**SUBJECT: CONTRACT NO. DE-SC0014664
INDEPENDENT CONFIRMATORY SURVEY SUMMARY AND
RESULTS FOR SURVEY UNIT L1010102 AT THE LA CROSSE BOILING
WATER REACTOR, GENOA, WISCONSIN
RFTA No. 18-003; DCN 5299-SR-02-0**

**INDEPENDENT CONFIRMATORY
SURVEY SUMMARY AND RESULTS FOR
SURVEY UNIT L1010102 AT THE
LA CROSSE BOILING WATER REACTOR,
GENOA, WISCONSIN**

FINAL REPORT

Figure 6.1. Q-Q Plot of ORISE Random Confirmatory Sample Results and LACBWR Sample Results by ROC

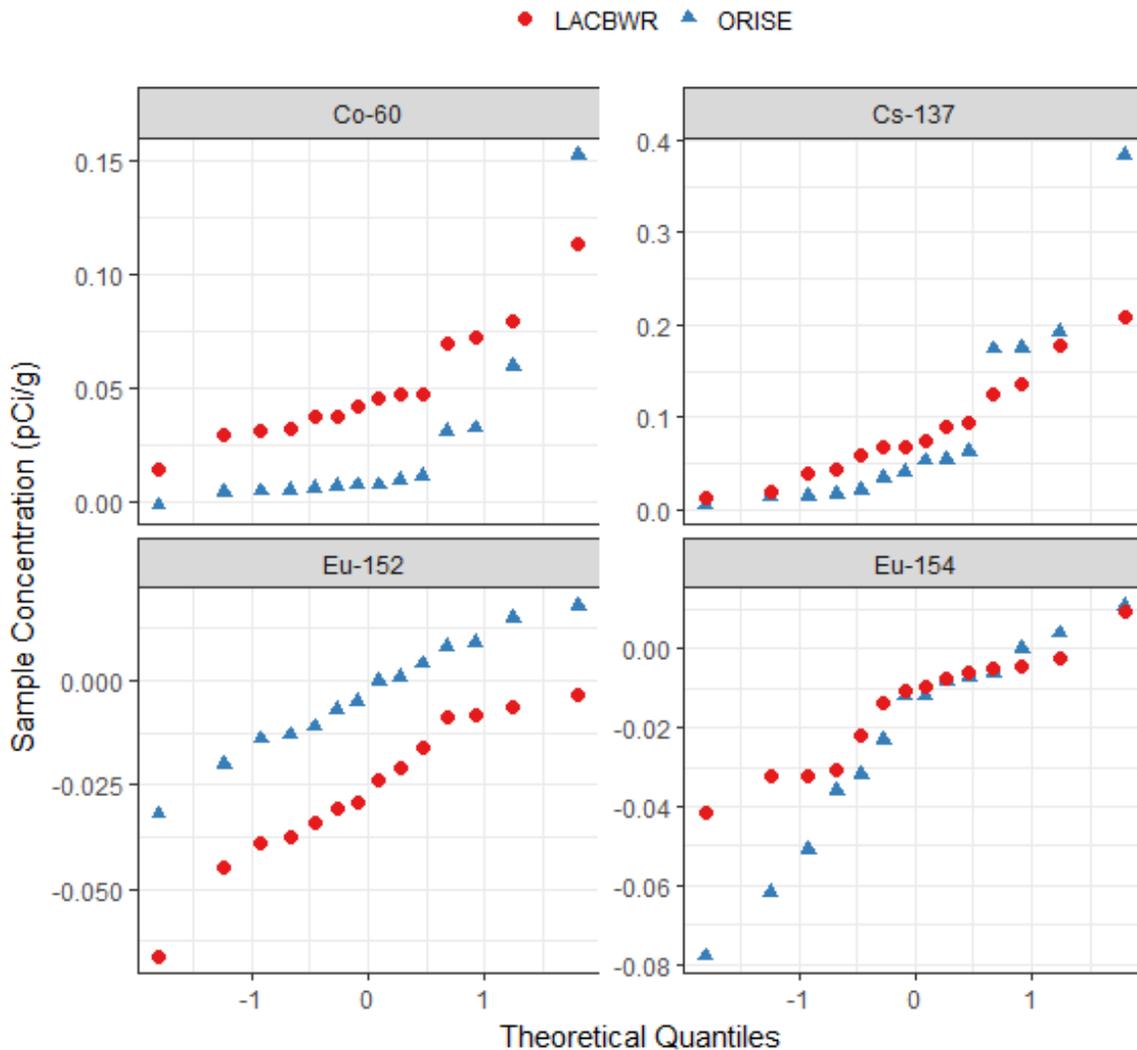
Figure 6.1 presents an individual Q-Q plot for each ROC. Based on the Q-Q plot for Cs-137, the ORISE data set appears to contain two populations and a potential outlier. Two populations are indicated by the distinct separation between the data points; below 0.065 pCi/g and above 0.17 pCi/g, as well as the step-shape of the data set. The highest observation at 0.384 appears to be a potential outlier; however, a formal outlier test was not performed. The data set collected by LACBWR, however, appears to follow a normal distribution, as indicated by the relatively linear shape of the data points. Review of the Co-60 Q-Q plot reveals a similar trend to that of Cs-137. The Q-Q plots for Eu-152 and Eu-154 represent a fluctuation in instrument background as neither ROC had concentrations above the MDC.

Due to the low number of detects for Co-60, Eu-152, and Eu-154, subsequent analysis with the WRS test was unnecessary and not appropriate for the Cs-137 sample sets. Based on the Cs-137 Q-Q plot review and general statistics in Table 6.1, it is apparent that the LACBWR sample set follows a normal distribution, whereas the ORISE sample set does not. Furthermore, the variance in the ORISE sample set is 4-times higher than that in the LACBWR data set, which violates a key assumption of the WRS test (the WRS test assumes that the sample sets have equal variance).

Figure A.1. Collimated Gamma Walkover Scan and Judgmental Soil Sampling Locations in SU L1010102

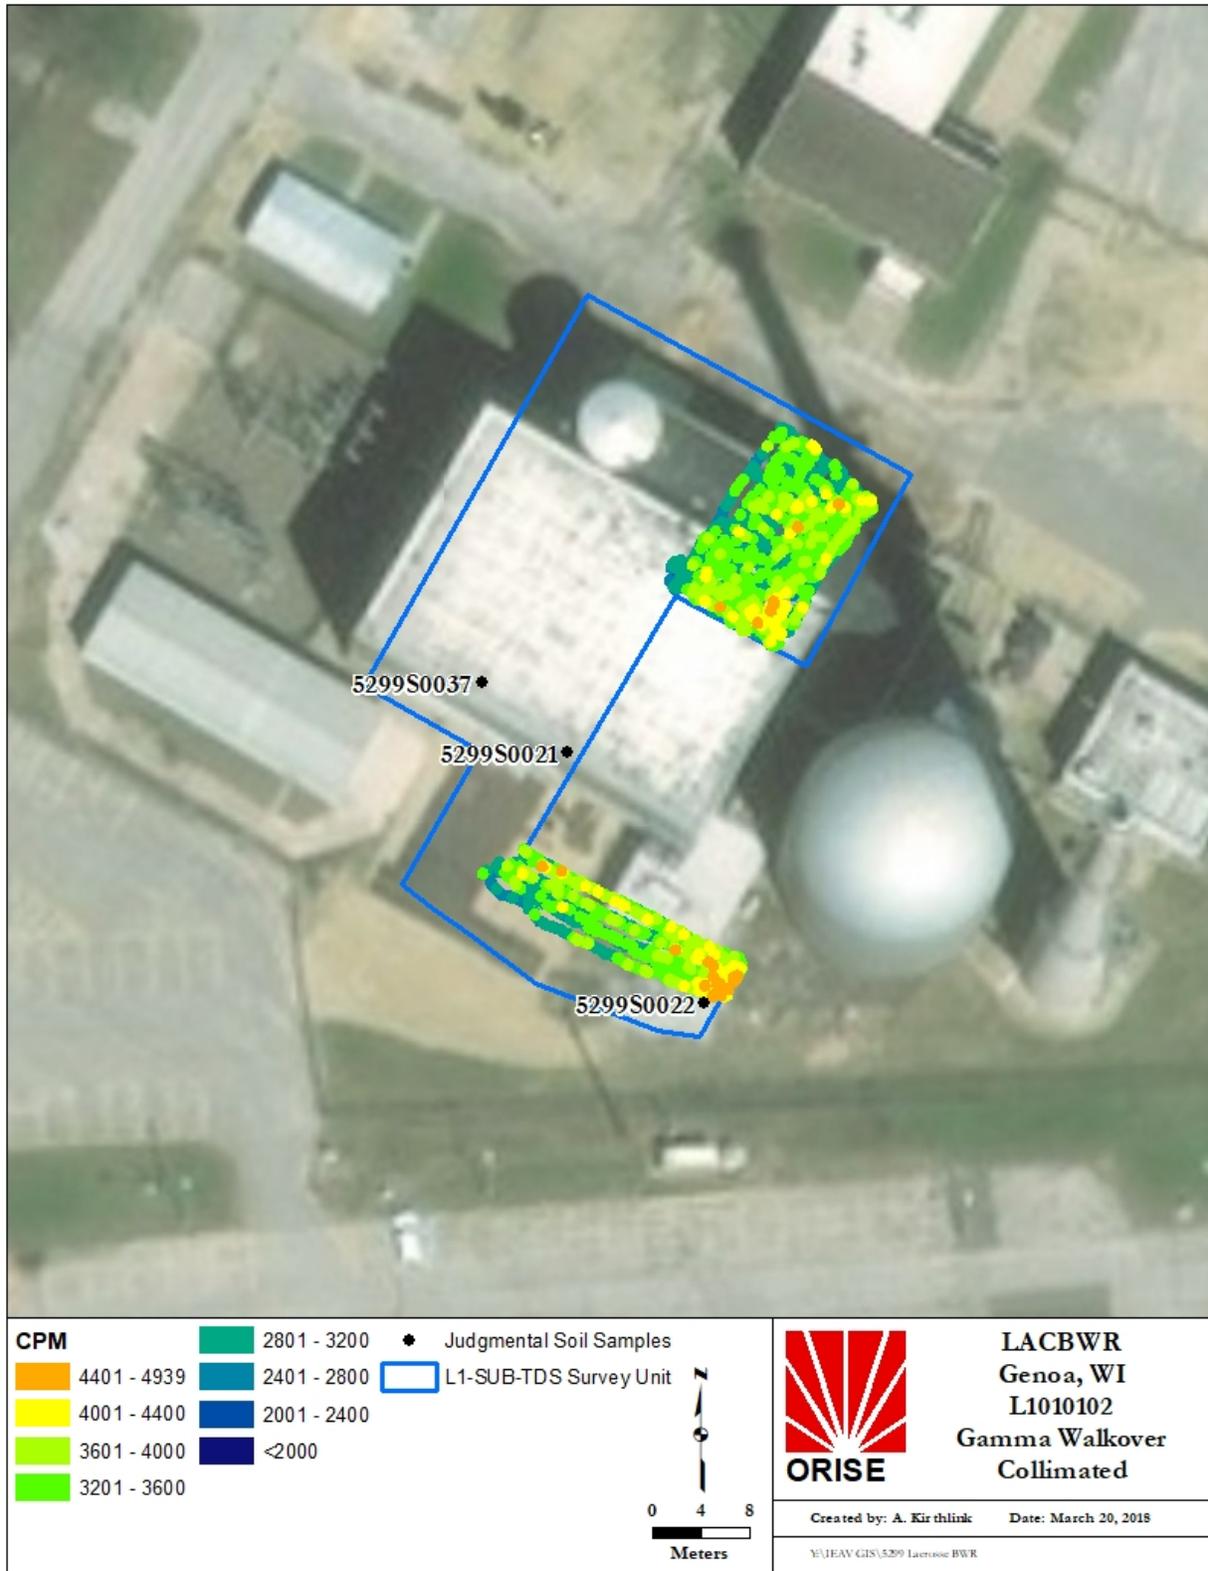
Figure A-1 illustrates scan data for the collimated NaI detector. The collimated detector response ranged from approximately 2,000 to 5,000 counts per minute (cpm) with higher detector response on the eastern side of this area, closest to the reactor building. Gamma radiation “shine” interference reduced with distance from this building.

As indicated in Figure A-1, there are scan coverage gaps associated with the eastern and southern survey unit boundaries. However, surveyors noted that scans were performed along the physical boundaries established by LACBWR, with exception of the aforementioned inaccessible portion. Sample S0022, shown in Figure A-1, was collected from the corner of the physical boundary established by LACBWR, indicative of the identified discrepancy between the planned boundary—established in the GIS files—and the physical survey unit demarcation.

ORISE noted one LACBWR FRS implementation discrepancy based on the post-survey review of the confirmatory survey gamma walkover maps. The planned survey unit boundary provided in the site's GIS file did not coincide with the physical boundary observed in the field. For future surveys, ORISE recommends the NRC confirm that the L1010102 adjoining shared survey unit boundaries encompass the discrepant physical soil area.

However, based on a post-survey review of the gamma walkover maps, there is an apparent discrepancy between the planned survey unit boundary and the physical boundary observed in the field. For future surveys, ORISE recommends the NRC confirm that the boundaries of the survey units surrounding L1010102 share physical boundaries such that 100 percent of the soil area is investigated.

Figure A.2. Uncollimated Gamma Walkover Scan and Judgmental Soil Sampling Locations in SU L1010102

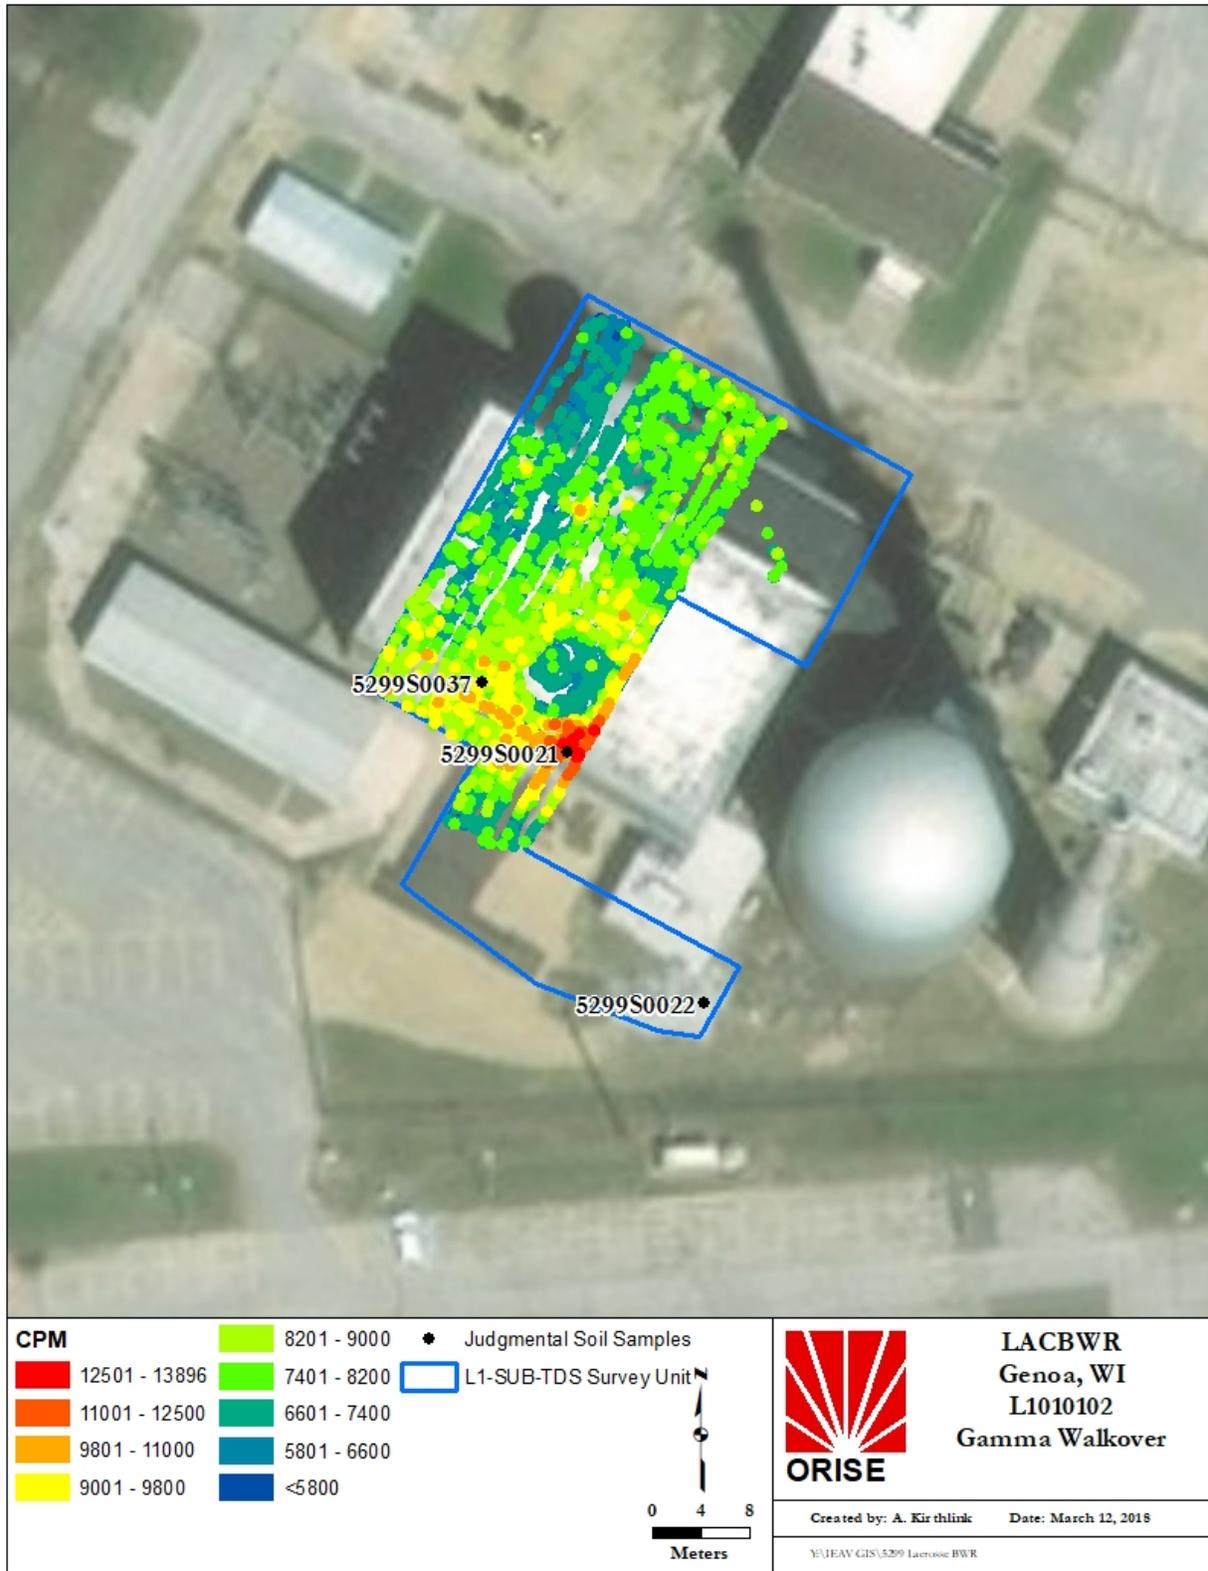
Figure A-2 illustrates scan data for the uncollimated NaI detector, which ranged from approximately 5,200 to 14,000 cpm. As with the collimated detector, counts tended to decrease toward the north western boundary. Detector response was also notably lower in the vicinity of the condensate pump excavation.
